Charlotte Department of Transportation

Memorandum

Subject: Rezoning Petition 13-067: Approximately 18.95 acres located on the west side of Northlake Centre Parkway near the intersection of Madison Square Place, Northlake Mall Drive and Northlake Centre Parkway.

Figure 1: Northlake Study Area Proposed Street Classifications Map - Northlake Area Plan

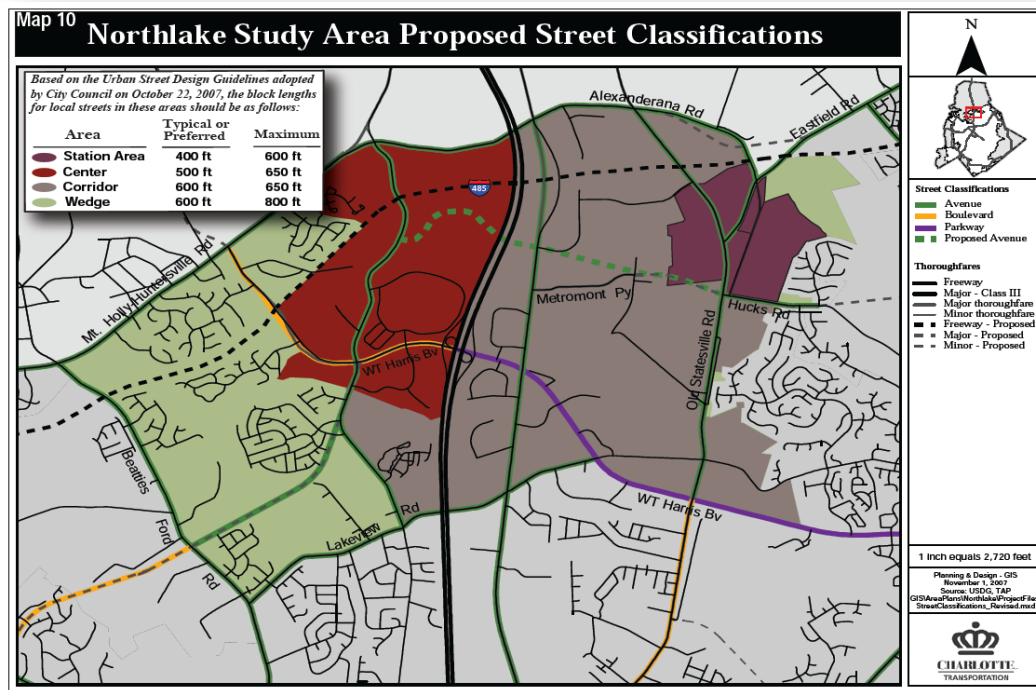
1. Based on the Northlake Area plan (we understand there is a recommended future Hucks Road street extension that will connect to Old Statesville Road to Northlake Centre Parkway Figure 1). While the final location of the proposed street connection to Northlake Centre Parkway has not been determined, we anticipate (if feasible) that it will align with the existing northernmost median opening. We request the petitioner add a call out conditional note on the Technical Data Sheet that acknowledges that any future street connection at the

northernmost existing median opening on Northlake Centre Parkway for parcels 025-081-22B & 025-081-23B will be subject to additional engineering design and evaluation, as this future street connection may function as a future full-access signalized intersection, serving both sides of Northlake Centre Parkway, including traffic generated from the proposed 416 dwelling units proposed in this petition.
